CITY OF ALBUQUERQUE

Re: Transport Apartments
2900 Transport St. SE
Traffic Circulation Layout
Engineer's Stamp 01-23-24 (M15-D023H)

Based upon the information provided in your submittal received 01-24-24, the above referenced plan cannot be approved for Building Permit until the following comments are addressed:

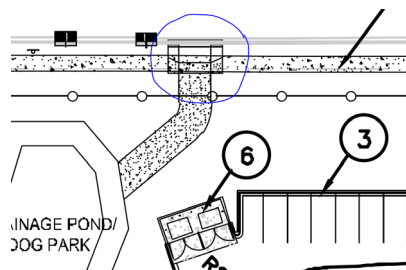
8. Key note 10: is it a median?
9. Please provide details for the sidewalk in this area.

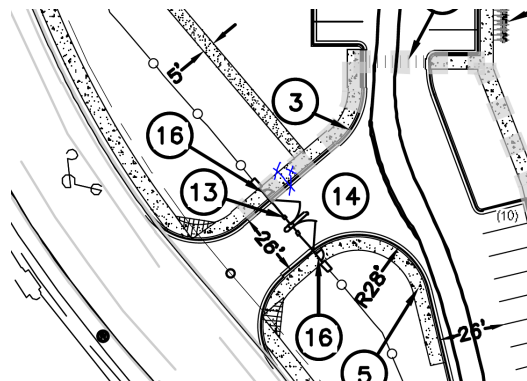
10. Please show on the site plan the width of the ADA pathway from the public sidewalk to the building entrance.

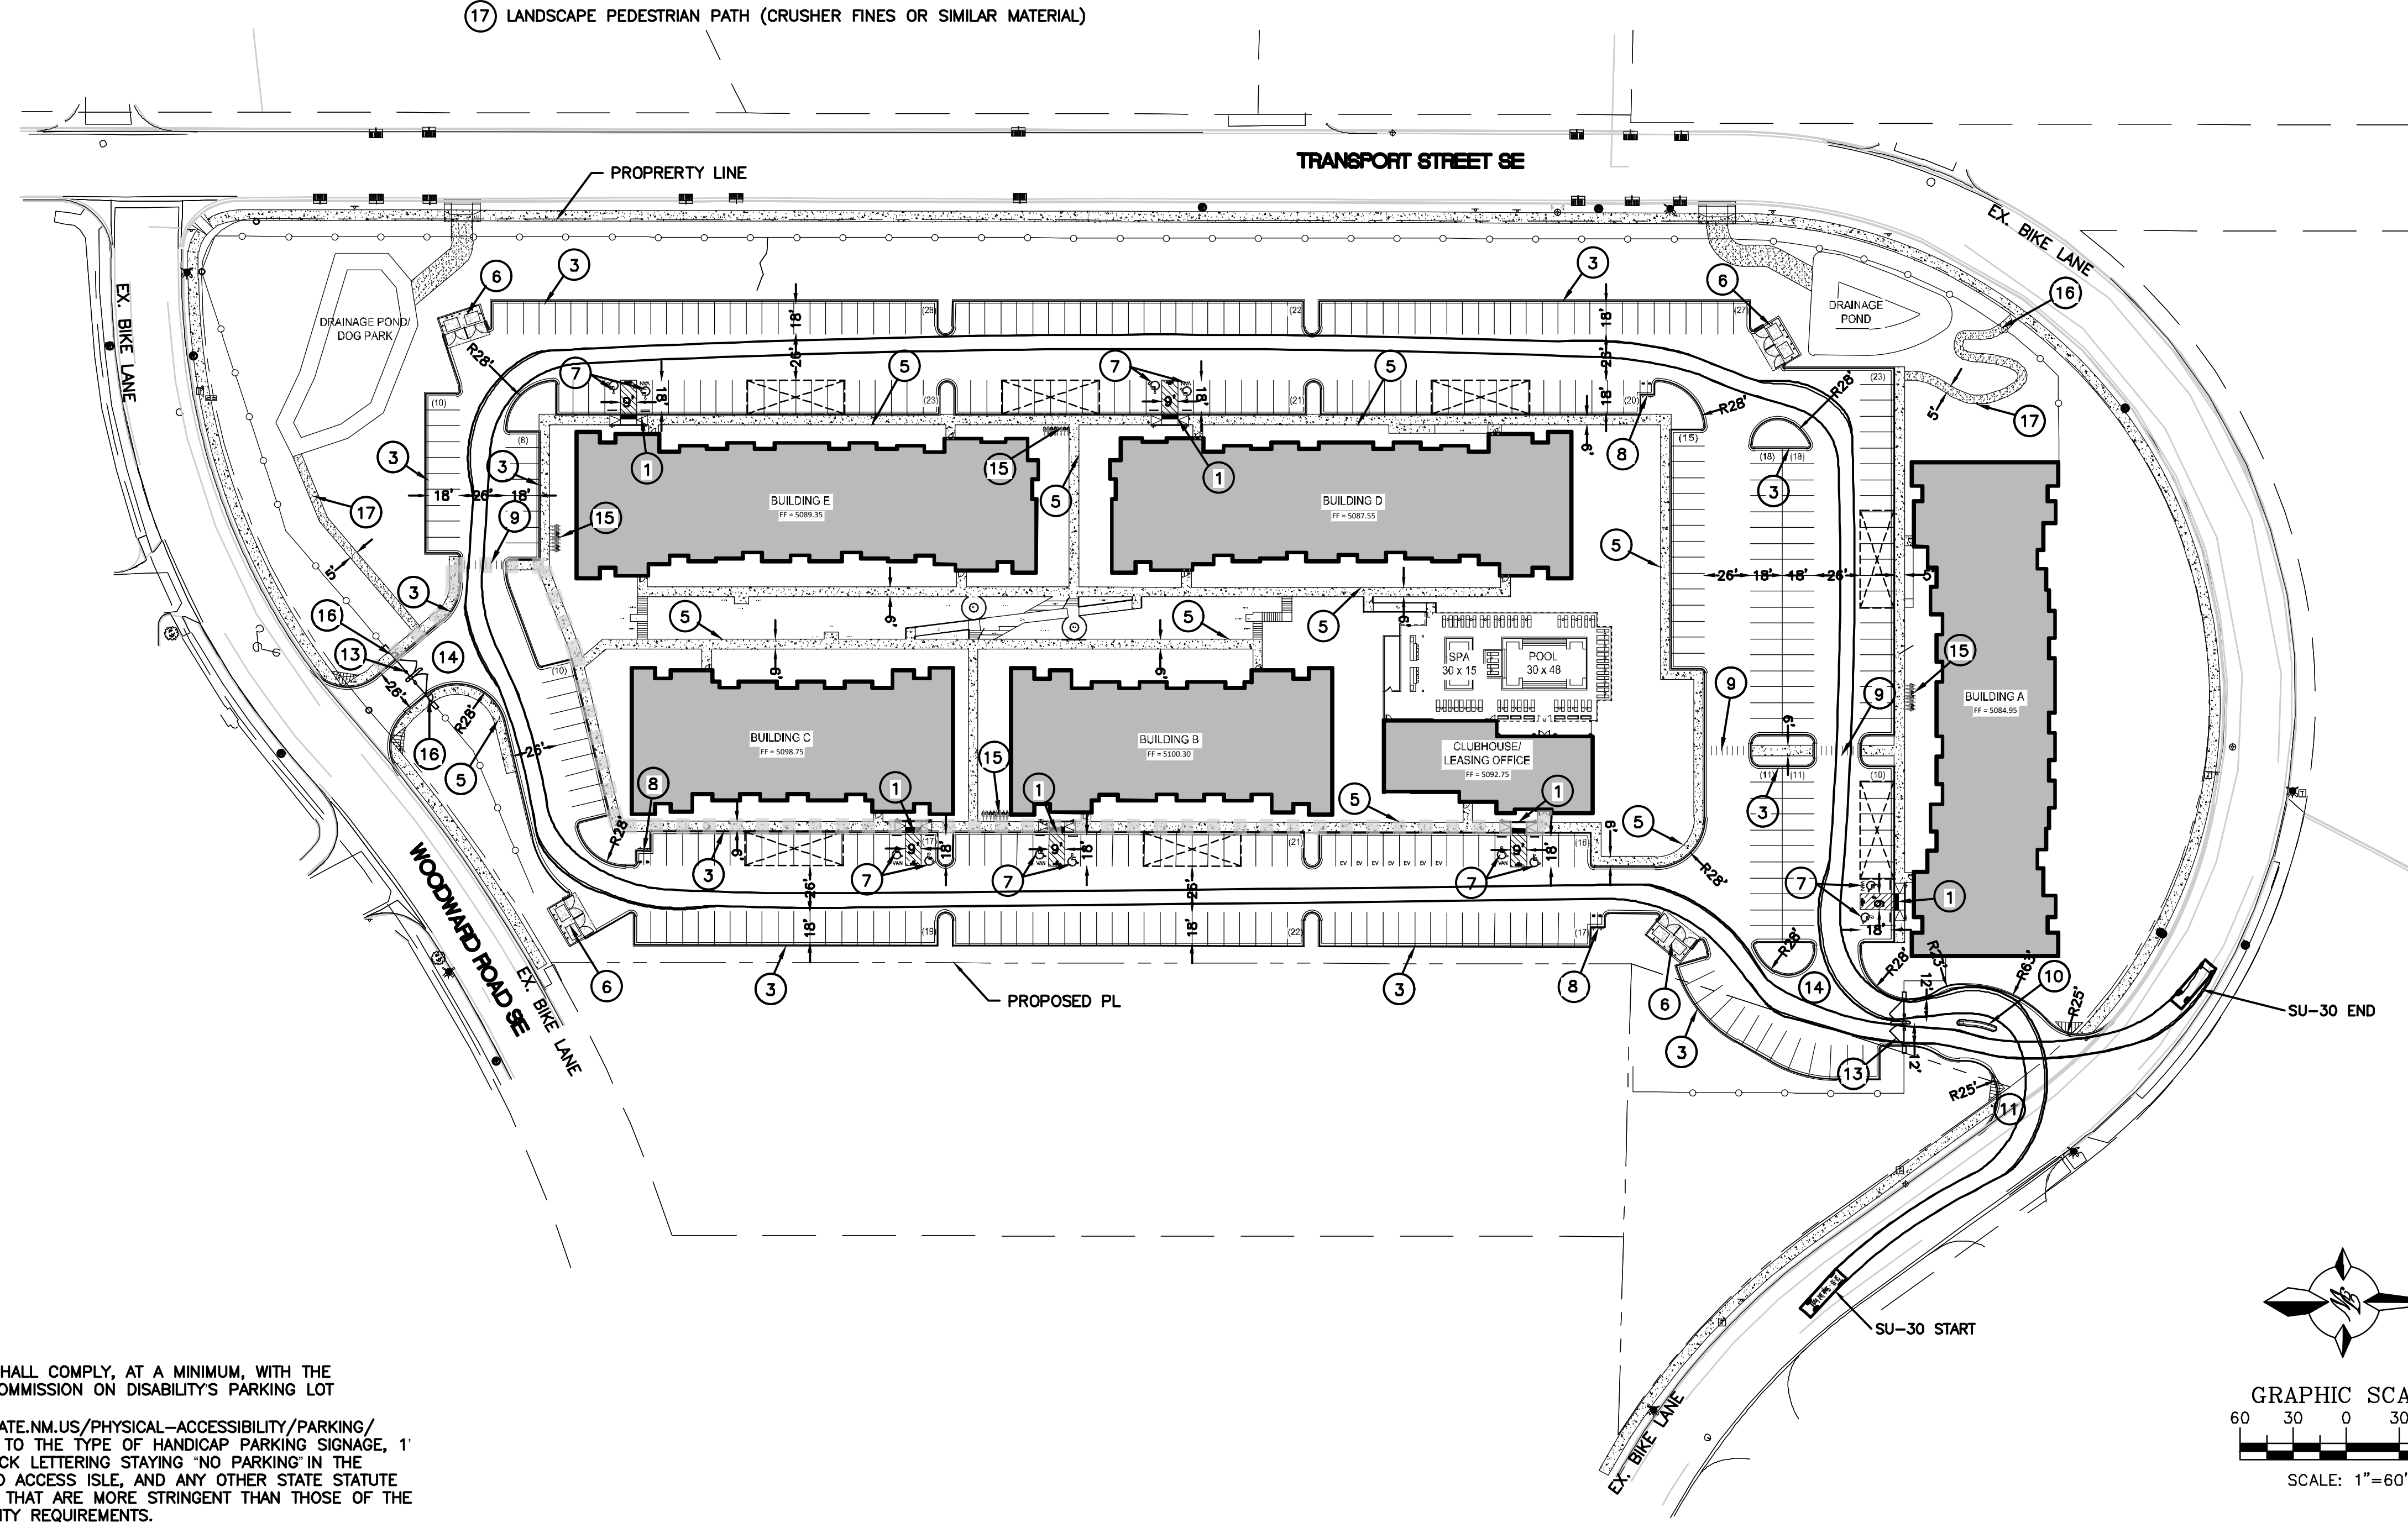
1. Identify the right of way width, medians, curb cuts, and street widths on Transport St. and Woodward Rd. SE.
2. Provide right of way improvement details:
 - Proposed sidewalk and buffer width and design details.
 - Proposed ADA ramp at the corner of Transport St. and Woodward Rd. details.
 - Proposed both site accesses details.
3. Per the DPM, please indicate a minimum throat length of 75 ft. for both site accesses.
4. Drawing is missing keynote 2.
5. Are you providing EV parking spaces less than the required number? Please address this concern.
6. Provide proposed standard parking spaces width.
7. Parking spaces at the east side of building A are out of the property.

11. Key note 13: Due to proposing a gate, please provide vehicle turning around template.
12. Provide a copy of Fire Marshal and Solid Waste approval.
13. Traffic Studies: See the Traffic Impact Study (TIS) thresholds. In general, a minimum combination of 100 vehicles entering and exiting in the peak hour warrants a Traffic Impact Study. Visit with Traffic Engineer for determination, and fill out a TIS Form that states whether one is warranted. In some cases, a trip generation may be requested for determination (**Contact Matt Grush: mgrush@cabq.gov**).
14. Please provide a letter of response for all comments given.
